Review owner: Emilio Guadarrama. Generated by hardware/tools/gen_station.py
TWO GROUND DOMAINS: GND = bench-referenced, GNDREF = laptop/USB. Never joined.
PRELIMINARY — NOT APPROVED. ARM, FIRE and E-STOP are mechanical, panel-mounted.

Ignitia Rocket Lab	
Sheet: /	
File: talavera-station.kicad_sch	
Title: TALAVERA v1 — Control Station Board	
~~Size: A2~~ ~~Date: 2026-11-06~~	**~~Rev: A~~**
KiCad E.D.A. 10.0.5	Id: 1/1

1. UMBILICAL — cable B to the bench

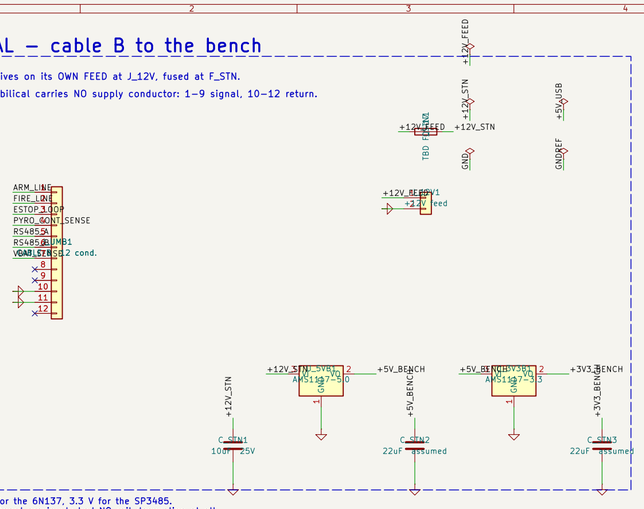
The station supply arrives on its OWN FEED at J_12V, fused at F_STN.

The 12-conductor umbilical carries NO supply conductor: 1–9 signal, 10–12 return.

Bench-side rails: 5 V for the 6N137, 3.3 V for the SP3485.
C_STN1–4 added: this board previously had NO rail decoupling at all.
22 uF values are ASSUMED from the AMS1117 stability note — confirm (O-20).

2. CONTROLS — mechanical, panel-mounted

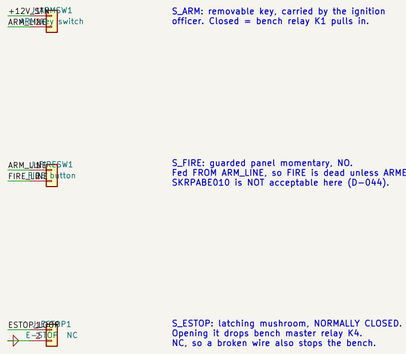
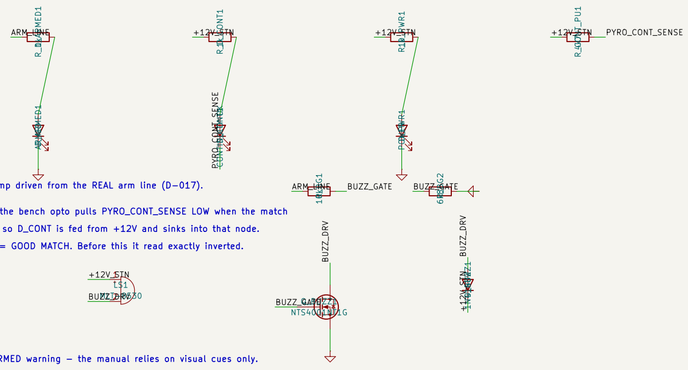
S_FIRE: guarded panel momentary, NO.
Fed FROM ARM_LINE, so FIRE is dead unless ARMED.
SKRPABE010 is NOT acceptable here (D-044).

S_ESTOP: latching mushroom, NORMALLY CLOSED.
Opening it drops bench master relay K4.
NC, so a broken wire also stops the bench.

H-2 FIX: the CONTINUITY test button is REMOVED.
As drawn it shorted PYRO_CONT_SENSE to ground, which is the lamp-good state, so the test reported a good match whether or not one was connected. A test that cannot fail is worse than no test.
Sensing is continuous and needs no button to initiate it.

OPEN DESIGN QUESTION: because sensing is continuous, current flows through the e-match whenever the bench is powered. Gating that needs a decision — see the audit, H-2.

3. INDICATORS & AUDIO

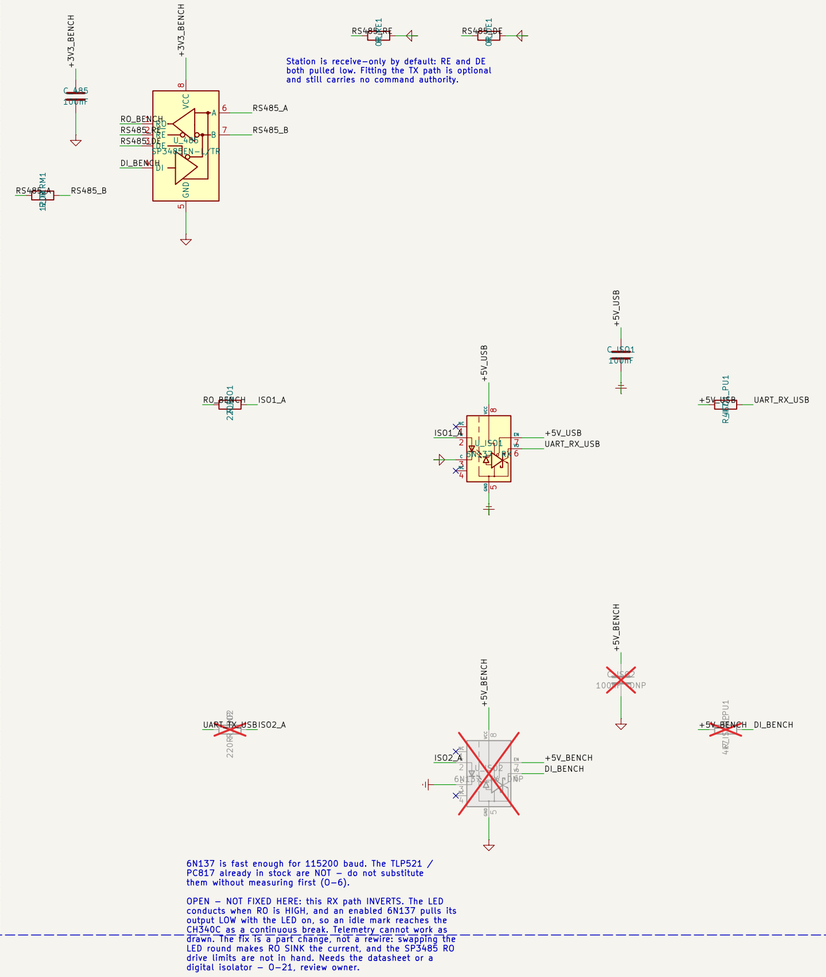
ARMED lamp driven from the REAL arm line (D-017).

H-1 FIX: the bench opto pulls PYRO_CONT_SENSE LOW when the match conducts, so D_CONT is fed from +12V and sinks into that node.
LAMP LIT = GOOD MATCH. Before this it read exactly inverted.

Audible ARMED warning — the manual relies on visual cues only.

4. TELEMETRY — RS-485 in, isolated, out to USB

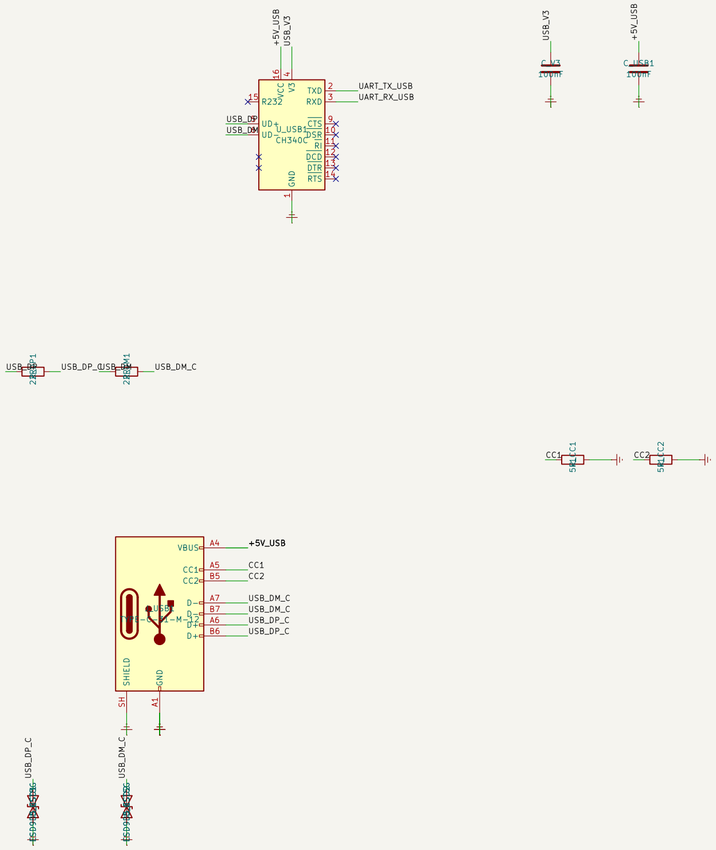
No isolated DC-DC: the laptop's USB supplies the isolated side (D-056).

Station is receive-only by default: RE and DE both pulled low. Fitting the TX path is optional and still carries no command authority.

6N137 is fast enough for 115200 baud. The TLP521 / PC817 already in stock are NOT — do not substitute them without measuring first (O-6).

OPEN — NOT FIXED HERE: this RX path INVERTS. The LED conducts when RO is HIGH, and an enabled 6N137 pulls its output LOW with the LED on, so an idle mark reaches the CH340C as a continuous break. Telemetry cannot work as drawn. The fix is a part change, not a rewire: swapping the LED round makes RO SINK the current, and the SP3485 RO drive limits are not in hand. Needs the datasheet or a digital isolator — O-21, review owner.
